**ON-SITE SEWAGE DISPOSAL SYSTEM
HOWARD COUNTY HEALTH DEPARTMENT
BUREAU OF ENVIRONMENTAL HEALTH**

SUBJECT: Variance Request

This letter is in reference to 4935 Valley View Overlook Ellicott City, MD. We are requesting permission to move the septic easement to 5' from the property line in order to accommodate a swimming pool.

BENCHMARK ENGINEERS ▲ LAND SURVEYORS ▲ PLANNERS ENGINEERING, INC. 8480 BALTIMORE NATIONAL PIKE ▲ SUITE 418 ELLICOTT CITY, MARYLAND 21043 PHONE: 410-465-6105 FAX: 410-465-6644 www.bei-civilengineering.com		HOMEWOOD CROSSING PLOT PLAN LOT 33 4935 VALLEY VIEW OVERLOOK TAX MAP 29, GRID 9 - PARCEL 28 3rd ELECTION DISTRICT HOWARD COUNTY, MARYLAND	
BUILDER: TOLL MD III LIMITED PARTNERSHIP 7164 COLUMBIA GATEWAY DRIVE SUITE 230 COLUMBIA, MARYLAND 21046 410-872-9105		HOUSE TYPE: CHAMBERLAIN MANOR ELEVATION	
DATE: JUNE 26, 2006		PROJECT NO. 1913	
SCALE: 1" = 40'		DRAWING 1 OF 1

LOT No. 33

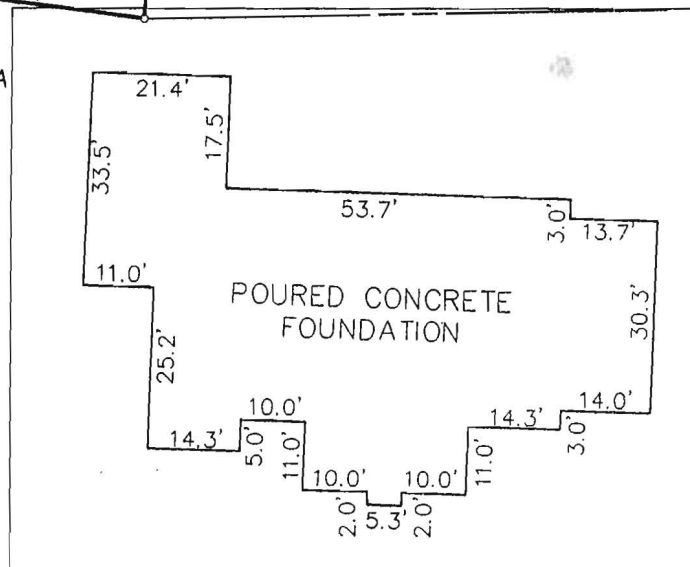
3/19/12 Contour shot in field. Start of trenches will shift slightly down hill. Install 2x85' trenches on contour. See reverse side for spec's. Call for map. install new D box and plumbing. (Kew)

INSTALLATION: 3/20/12 Bottom trench dug. Stone arriving on site very slow. Plumbing into line from existing S.T. OK to continue (pm)
3/21/12 (am) Lower trench complete. Top trench 50% complete. Container being held throughout. OK to continue (pm)
3/21/12 (pm) Trenches complete. OK to cover all work.
